Now on this day, the County Commission of the County of Boone does hereby approve a variance to allow a minimum sag vertical curve K Value of 26 in lieu of the 40 required for Local Roads in Table A – Road Construction Minimum Standards, Appendix ‘A’ of the Chapter II Roadway Regulations for the sag vertical curve near station 12+50.00 of the proposed Amicus Drive in Midway Crossings Plat 3 contingent upon the Developer providing street lighting at the Developer’s expense prior to County acceptance of the roadway for maintenance.

RE: Recommendation for Variance Request to the Chapter II Roadway Regulations
Midway Crossings Plat 3

RE: Midway Crossings Plat 3 – Amicus Drive K-Value Variance

Exhibit 3-74. Design Controls for Sag Vertical Curves—Open Road Conditions

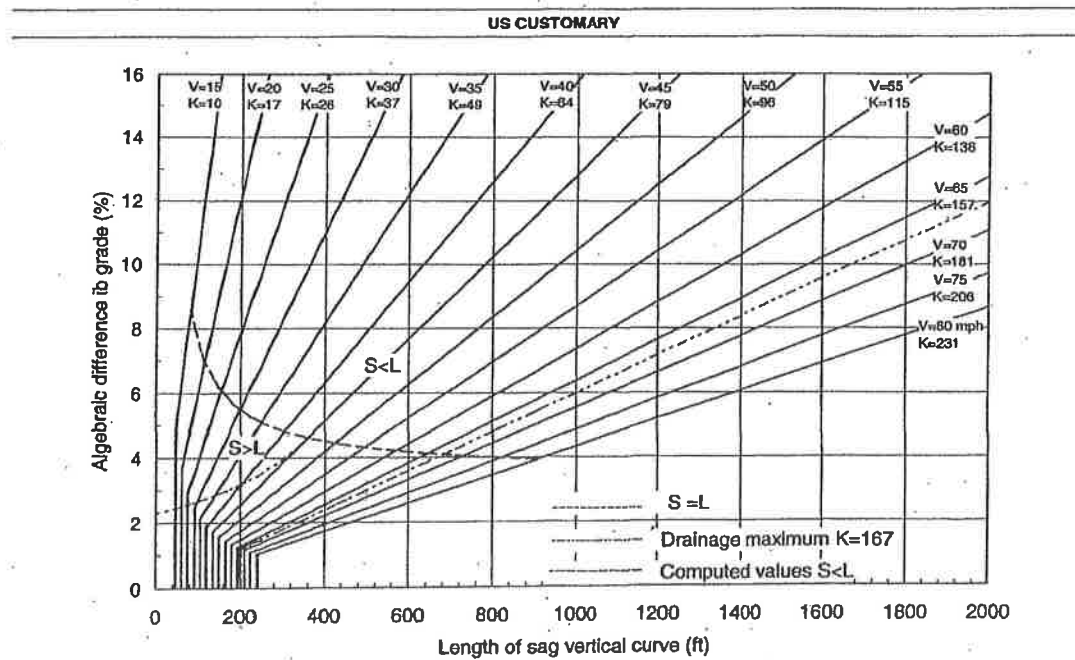
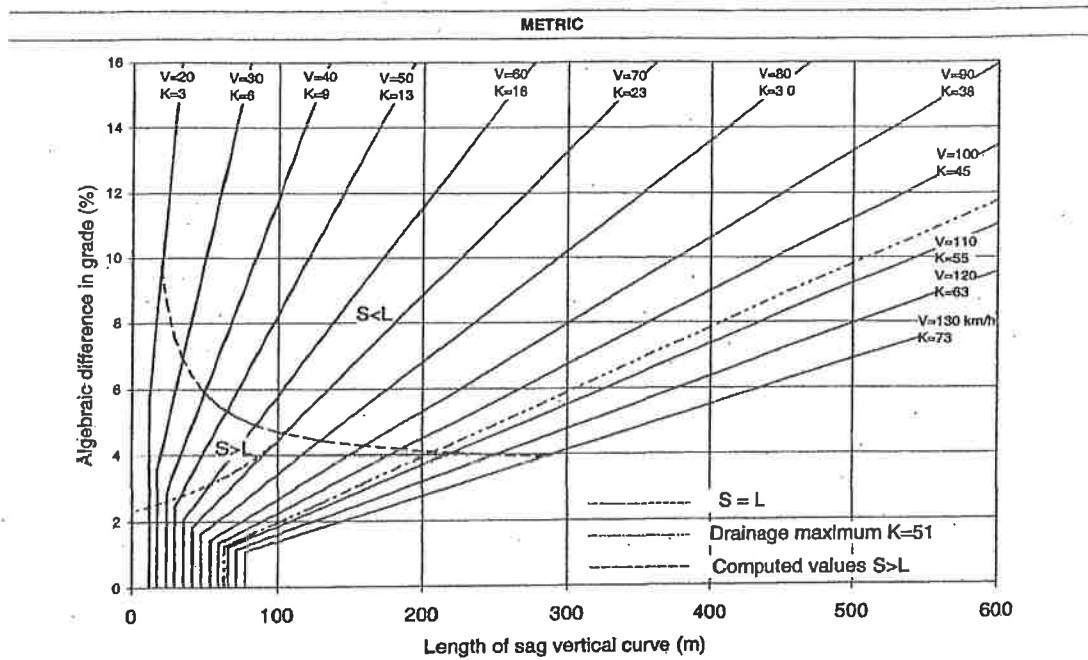
It is our understanding that the County's K Value requirement is based on a stopping sight distance of 200' for a design speed of 30 mph, as defined in the AASHTO Green Book (see attached AASHTO Sag Vertical Curve Design Criteria, Exhibit 3-75 shows design K Value of 37 for the above described situation). However, the limiting factor causing this K value is headlight sight distance. As part of this development and variance request, we would make contingent that Street Lighting be installed along Amicus Dr.

Therefore, the new limiting criteria, as outlined in AASHTO Green Book, would be passenger comfort. This criterion is reported as being approximately 50% of that needed to satisfy the headlight sight distance criterion, or approximately $37/2 = 18.5$.

Staff supports this variance request to allow a minimum sag vertical curve K Value of 26 in lieu of the 40 required for Local Roads in Table A – Road Construction Minimum Standards, Appendix 'A' of the Chapter II Roadway Regulations for the sag vertical curve near station 12+50.00 of the proposed Amicus Drive in Midway Crossings Plat 3 contingent upon the Developer providing street lighting at the Developer's expense prior to County acceptance of the roadway for maintenance.
